Groundwater Transfer Review Summary Form

Transfer/PA # T- 14681

Ground Water Review Form:

Application: T-14681

Stream Depletion Analysis-POA 1

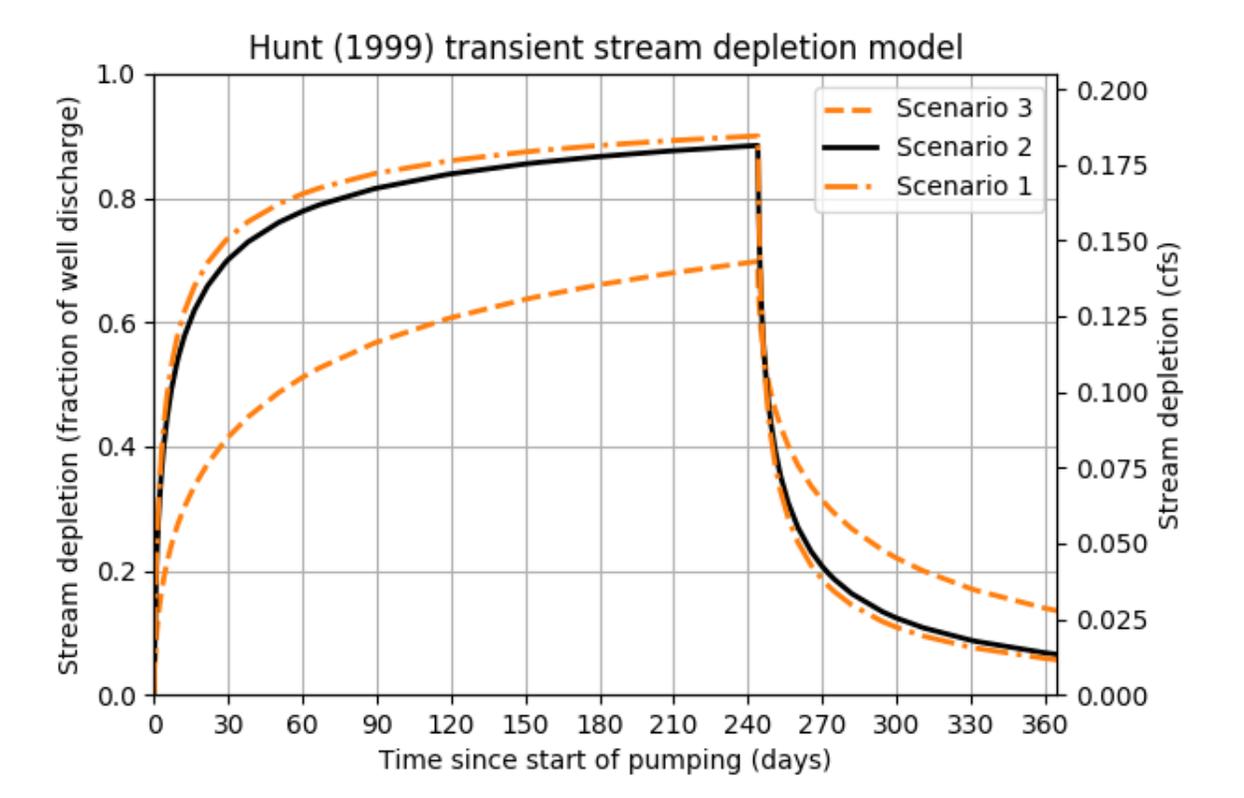
- Yes No Comments: OAR 690-380-2130 includes two components to the definition of similarly: a location component and a stream depletion component. The groundwater POAs are within 500 ft of the surface water source and within 1000 ft upstream or downstream of the surface water PODs. For the stream depletion component, the Hunt (1999) model was used to assess whether the proposed groundwater POAs, POA 1/Well 1 (PROP 720) and POA 2/Well 2 (PROP 721), would meet the definition of “similarly” per OAR 690-380-2130 (see attached Stream Depletion Analysis); this definition requires that greater than 50 percent of the groundwater POA pumping rate be derived from stream depletion within 10 days of continuous pumping. The Hunt (1999) model was selected due to the apparent unconfined nature of the aquifer anticipated to be developed by the proposed POA. Parameters used in the Hunt (1999) model were derived from regional data and studies (Pumping Test Reports; Conlon et al., 201; Herrera et al., 2014) or are within a typical range of values for the given parameter within the hydrogeologic regime (Morris and Johnson, 1967; Heath, 1983). Results of the analysis indicate that the proposed groundwater POA will likely derive greater than 50 percent of its pumping rate from stream depletion within 10 days of continuous pumping (see attached Stream Depletion Analysis). **The proposed change in point of diversion will likely affect the Willamette River “similarly” (per OAR 690-380-2130) to the authorized points of diversion in Certificates 32467 and 5492.**
